December 13, 2019

**Addendum No. 02
TO THE CONTRACT DOCUMENTS FOR:**

MANSFIELD FIRE STATION NO. 4

KAI Project No. 2016.166

SHEET SIZE: 22 x 34
JOB NO: 2016.166
DATE: 12/13/2019
SHEET: **C5.0**

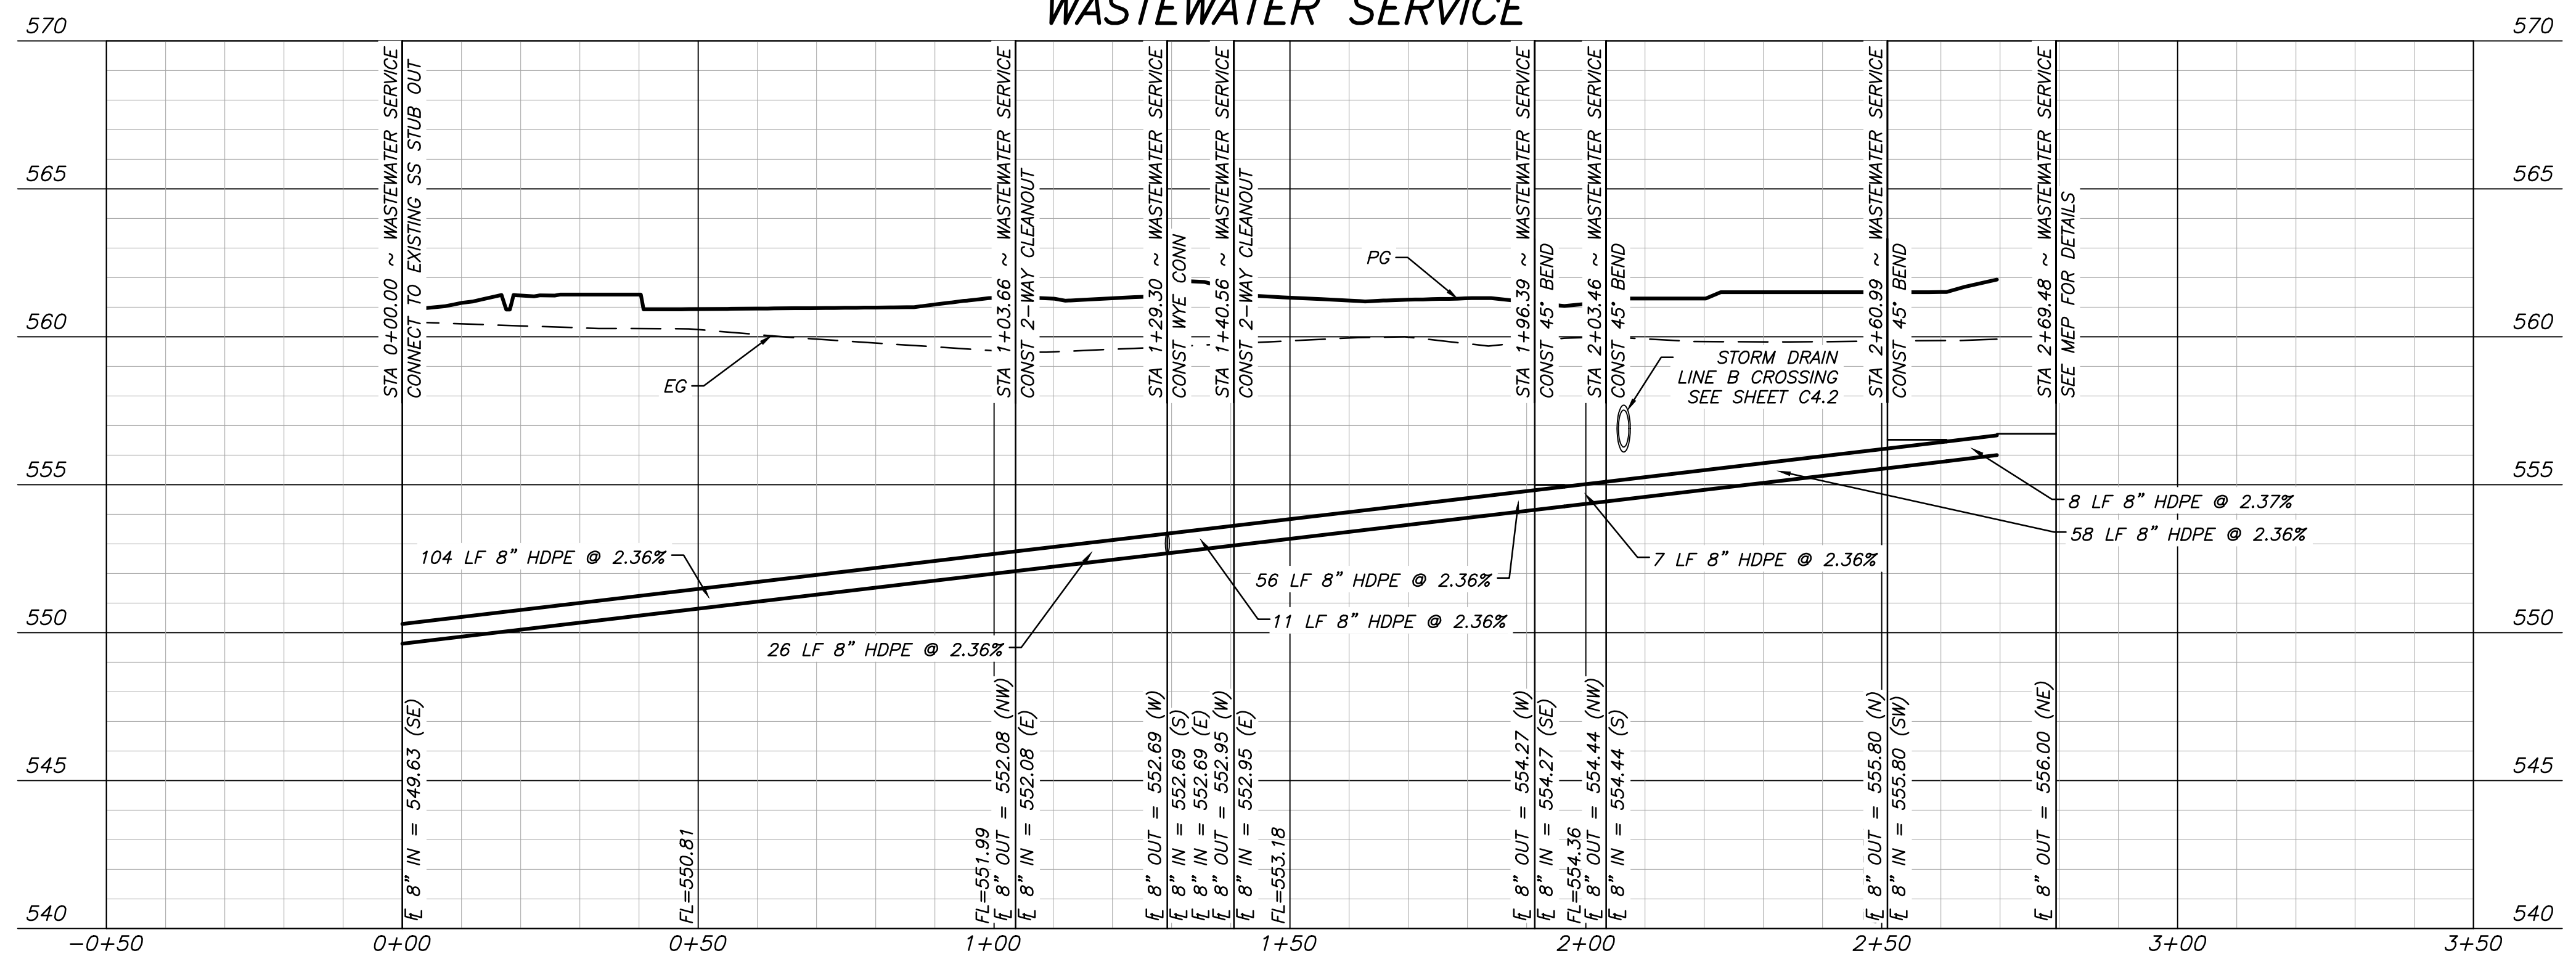
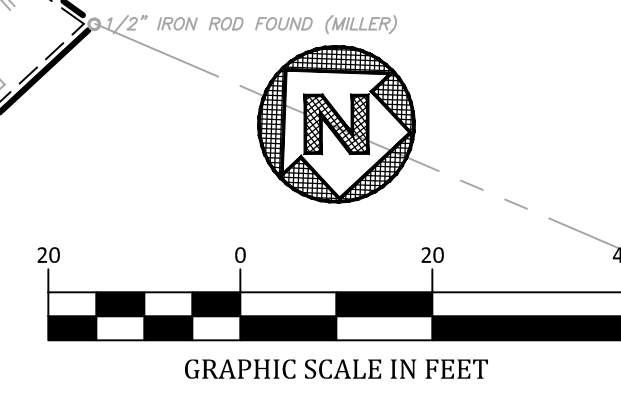
1. Sheet C5.0 – Revised sewer line.
2. Sheet C6.0 – Revised Gas and Fire line alignment.
3. Sheet A0.01 – See revised sheet to show drive revision to Holland Lane
4. Sheet A0.02 – See revised sheet for added dimension to 1/A0.02.
5. Sheet A1.01 – Added note 30.
6. Sheet A1.02 – Plan 2 – Clarified canopy dimensions and drainage. Added Note 7.
7. Sheet A4.06 – Detail 7 – Clarified Canopy fascia curb for canopy drainage.
8. Sheet A5.02 – Plan 2 – Revised size of Kitchen Island.
9. Sheet A5.03 - Omit B6 type accessory from project.
10. Sheet A5.06 – Elevation 12 and 17 – Revised width per island change.
11. Sheet S2.10 – Plan 1 – Revised grade beam in Bay. SLAB SCHEDULE – Revised bar sizes.
12. Sheet M0.02 – MULTI-ZONE DX SPLIT SCHEDULE revised.

| SHEET: | | C6.0 | | Date: 12/13/2019 | |

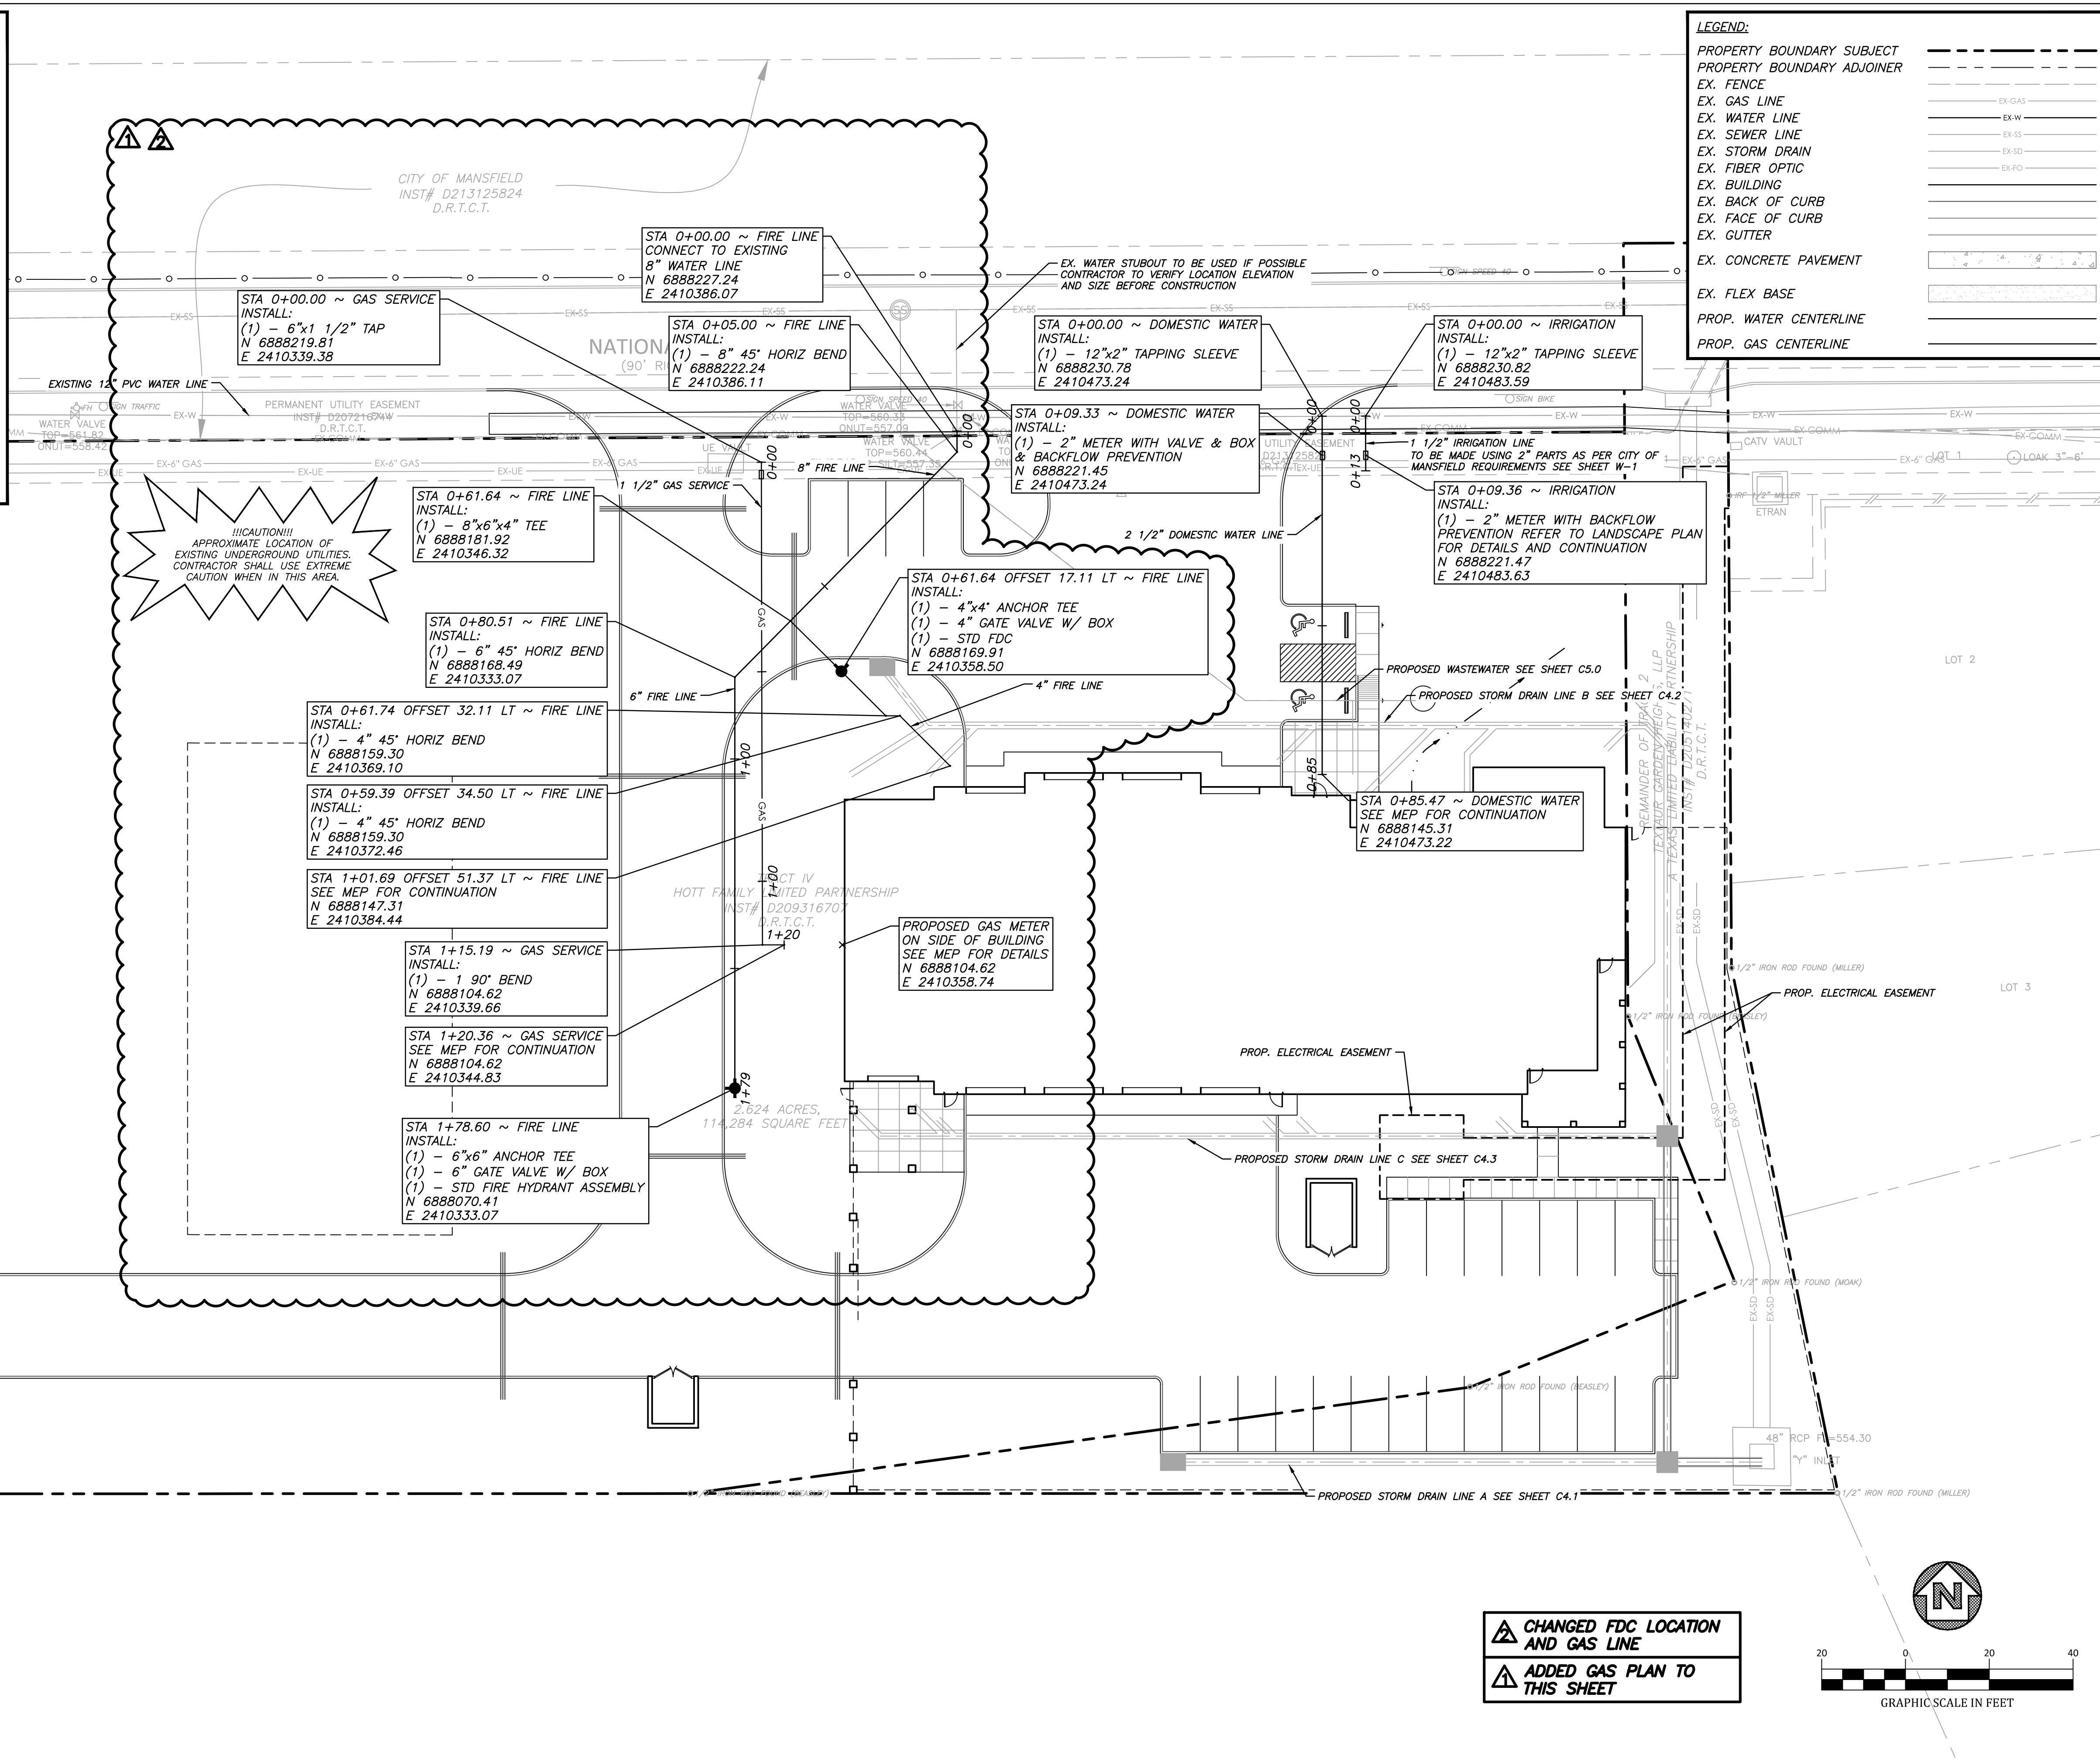
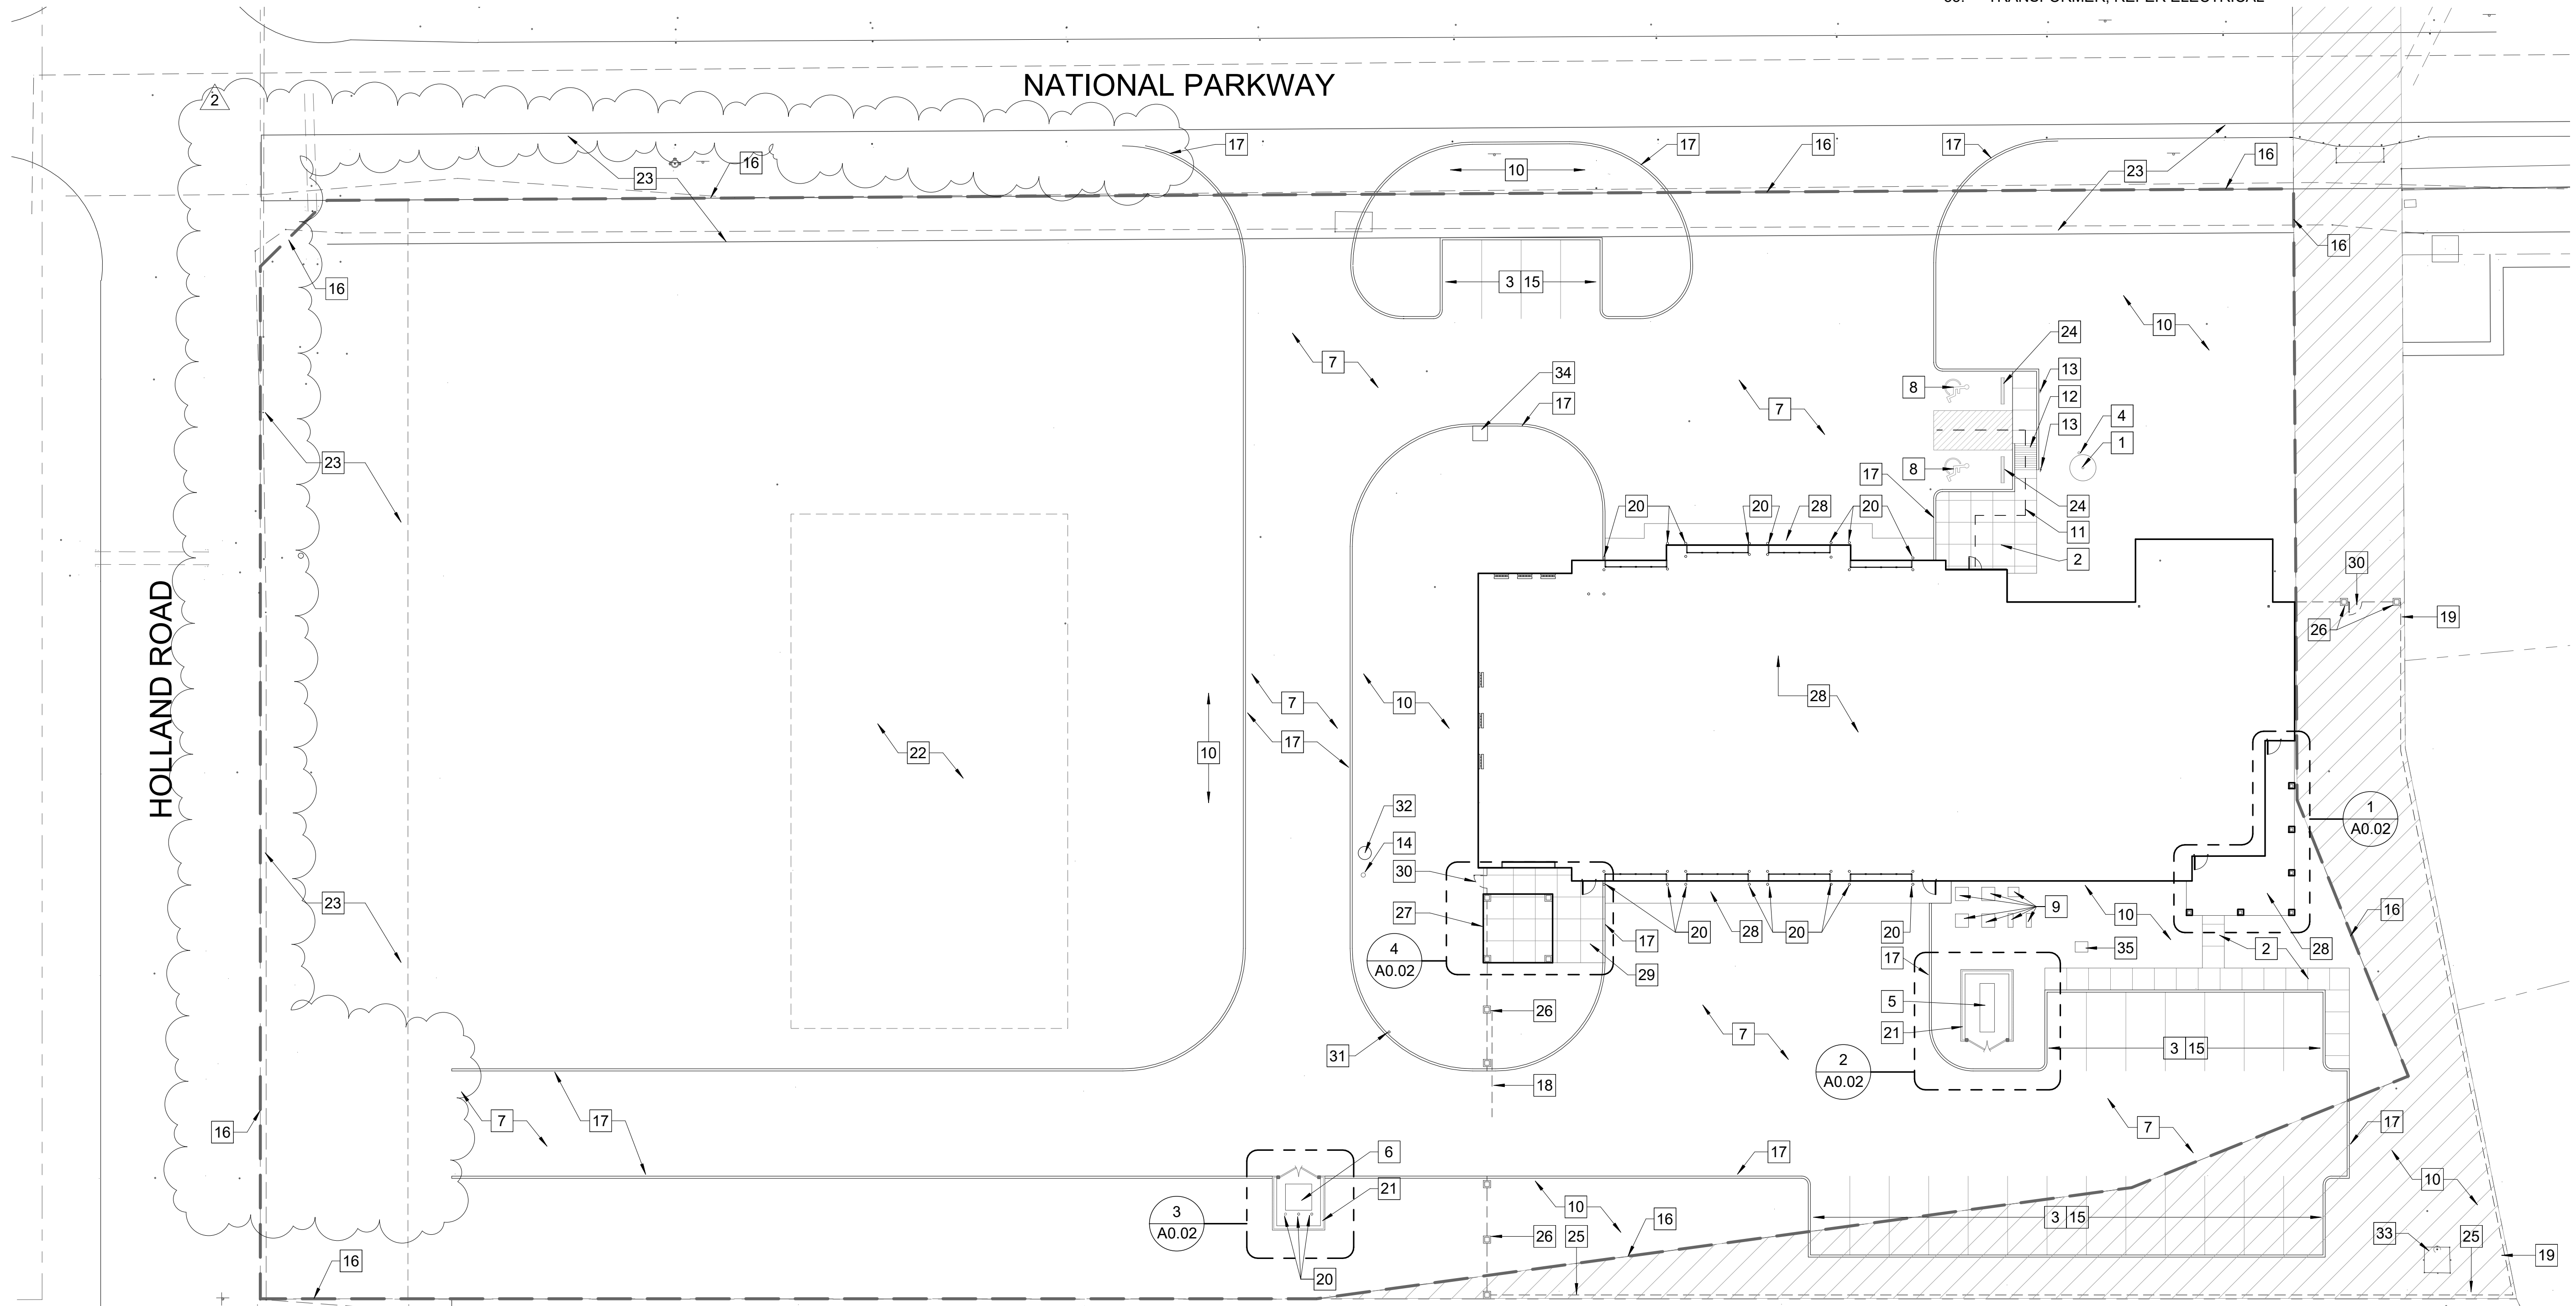
CHANGED FDC LOCATION AND GAS LINE
ADDED GAS PLAN TO THIS SHEET
